**LAKE MANITOBA AND LAKE ST. MARTIN OUTLET CHANNELS PROJECT
SUPPLEMENTAL SUBMISSION**

**MTI's response to IAAC's Attachment 1: Outstanding Information in
Response to Information Request Round 1 (Amended)
(dated June 6, 2022 and amended June 22, 2022)**

Attachment 1: Outstanding Information in Response to Information Request Round 1 (Amended)

Lake St. Martin: Post-Project 2011 Flood Peak

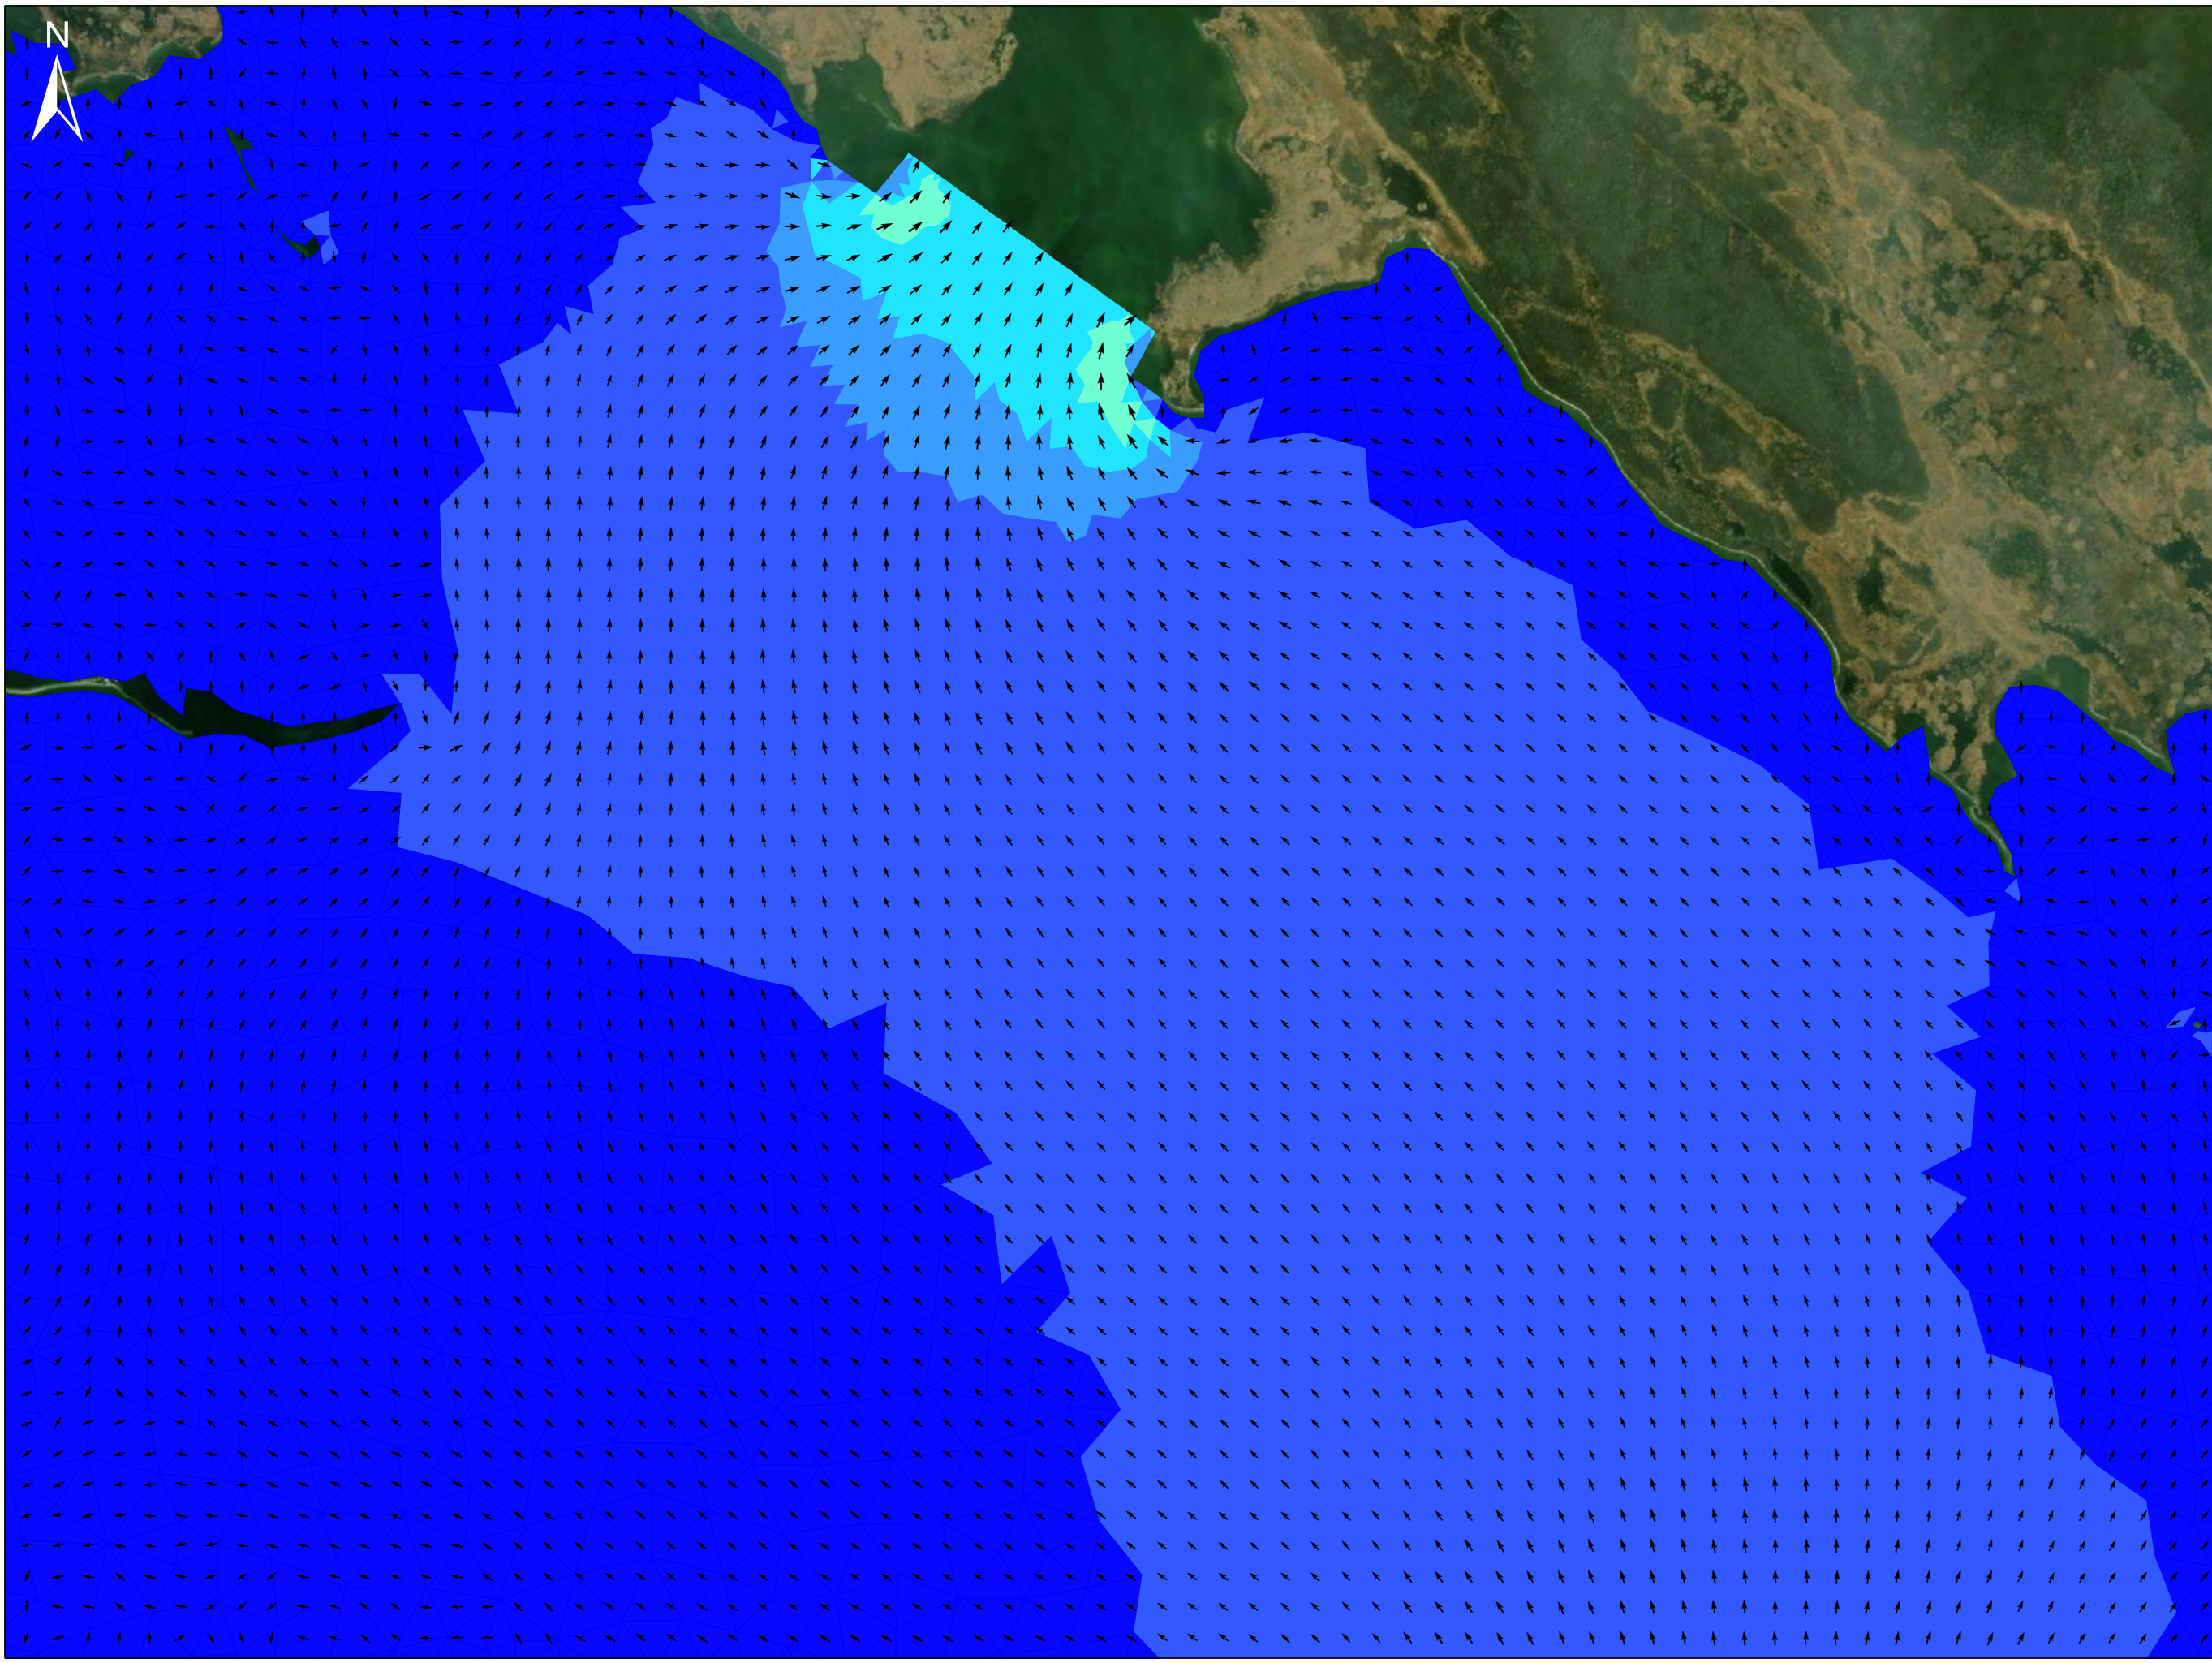
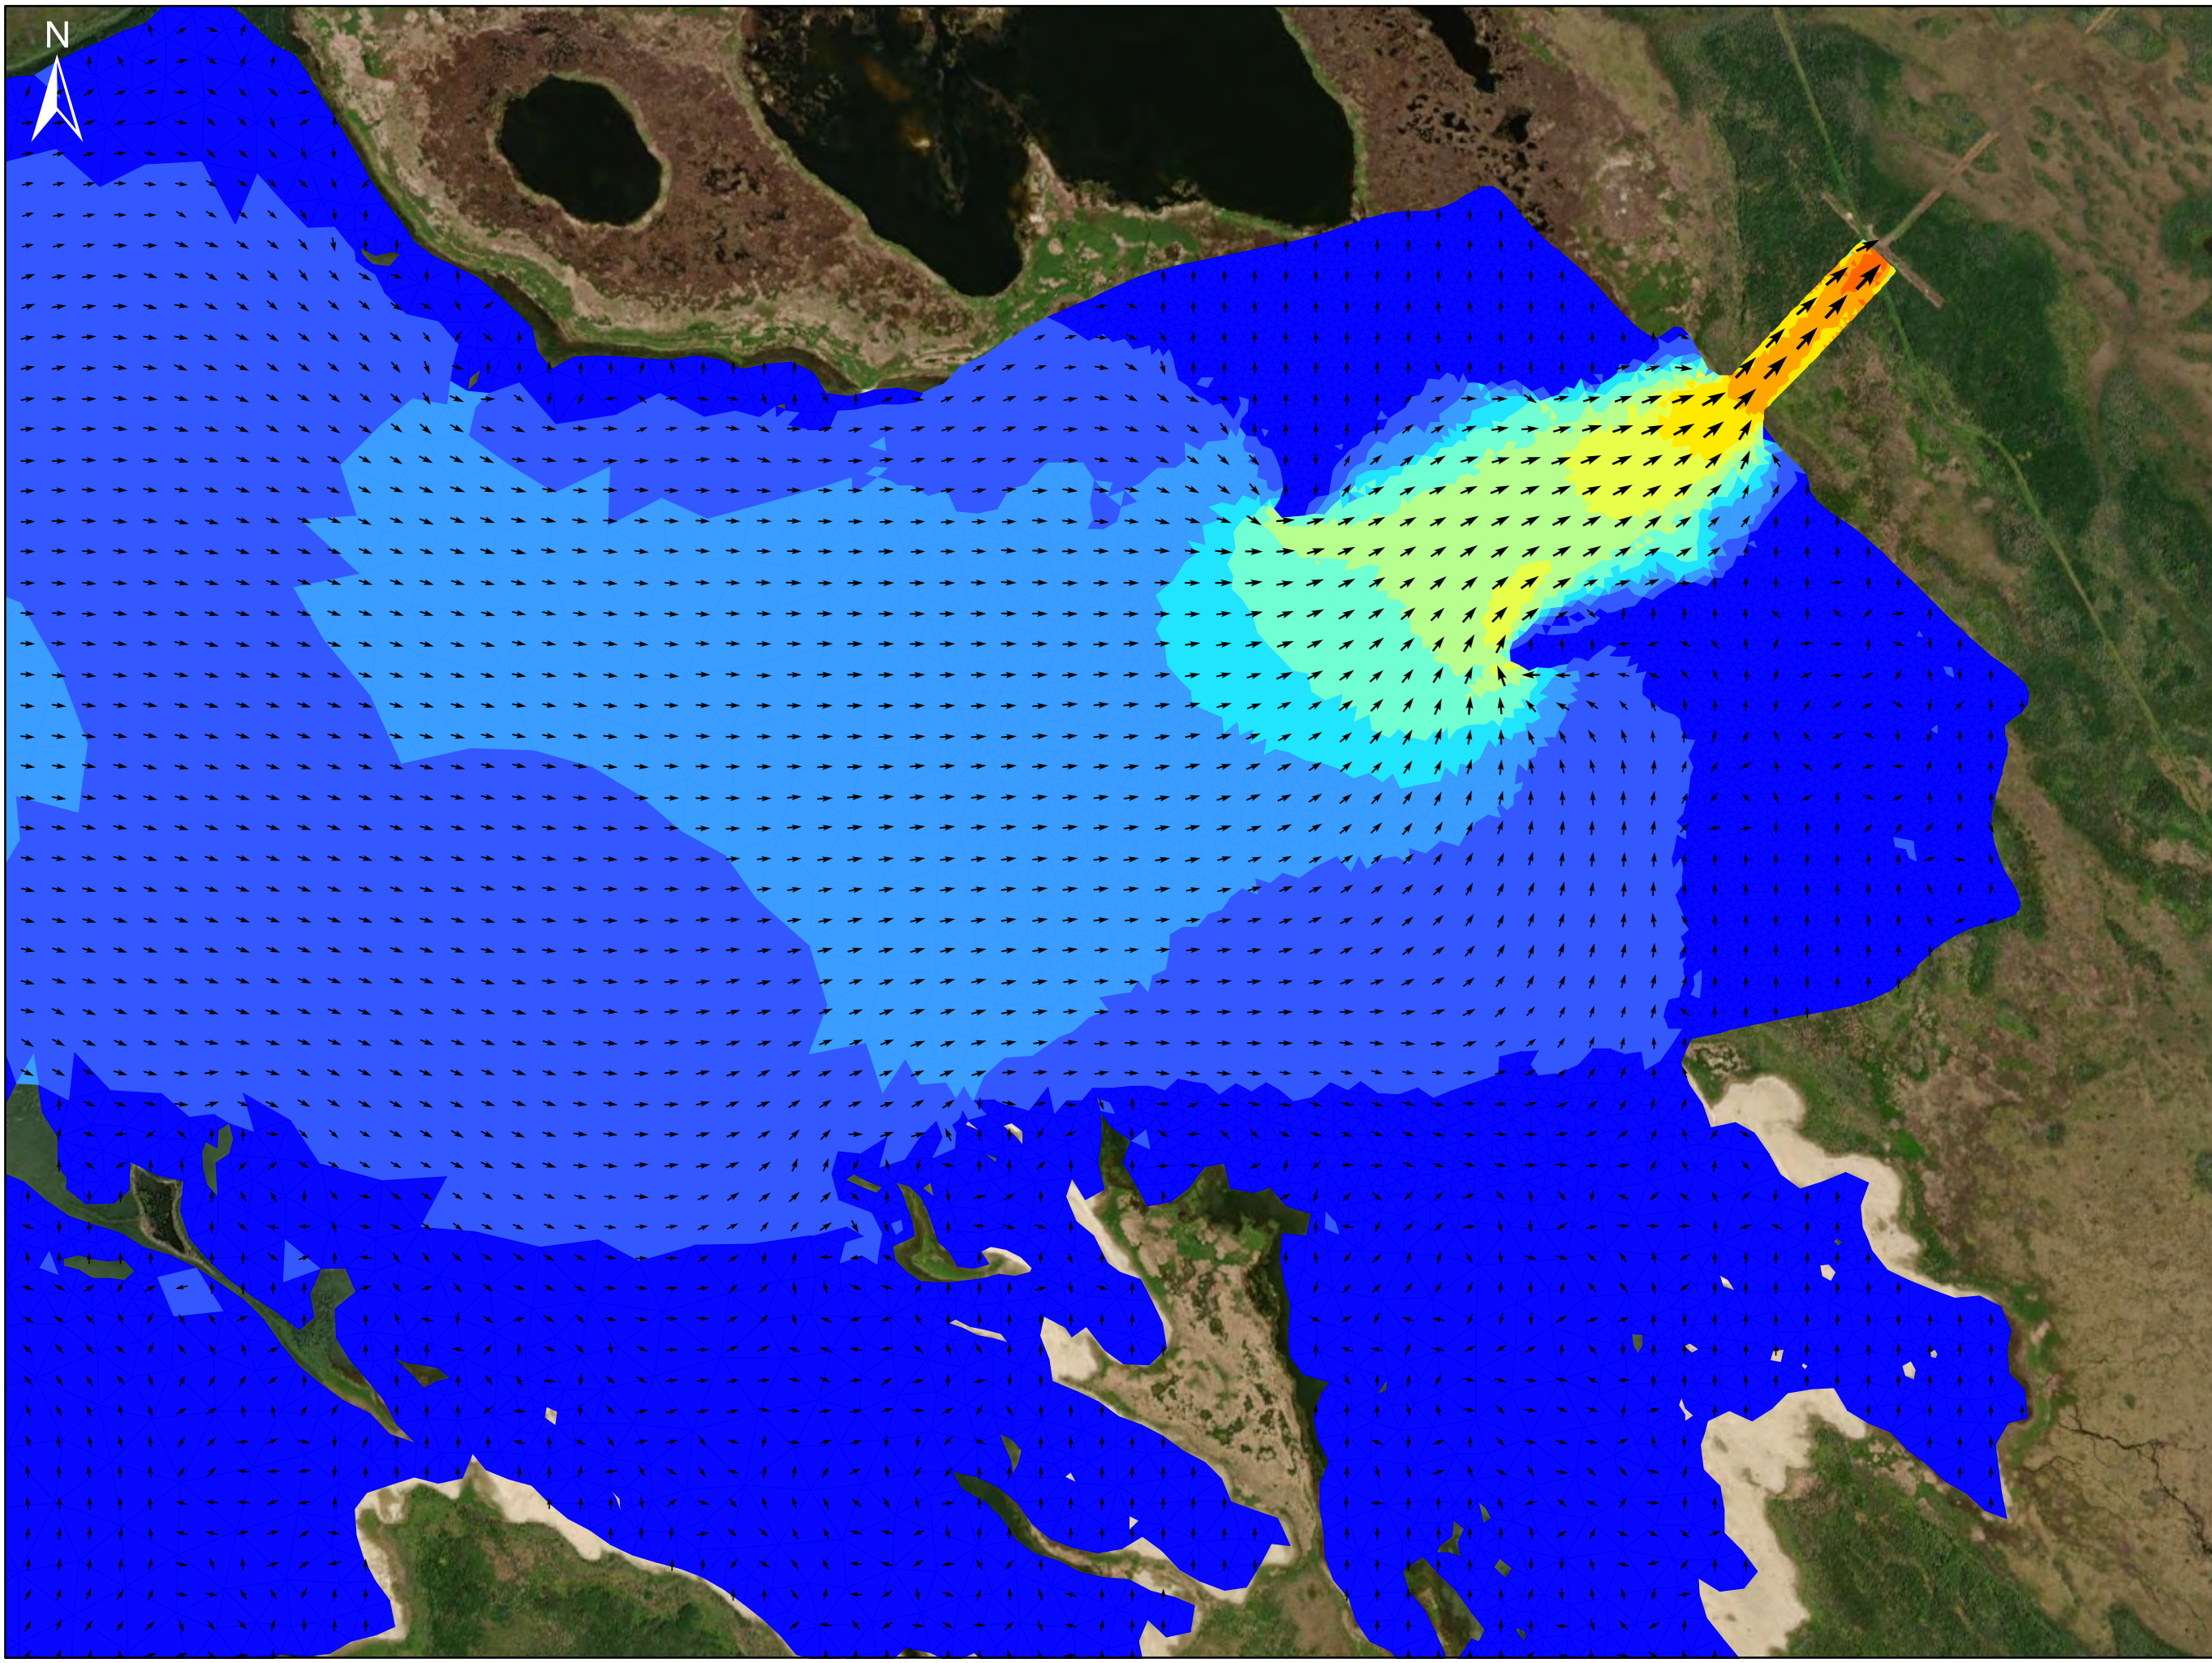
| # | Item | Comment | Request | Response (revisions shown in red) |
|----|---|--|---|---|
| 20 | IAAC-84: Missing Information | Appendix IAAC-84A appears to be missing. | Provide the missing information. | Appendix 84A: Velocity contour maps for Lake St. Martin illustrating passage of the 2011 peak flows for the pre- and post-Project environment are included in Appendix IAAC-84A This information is included; see the Appendix 84A velocity figures |
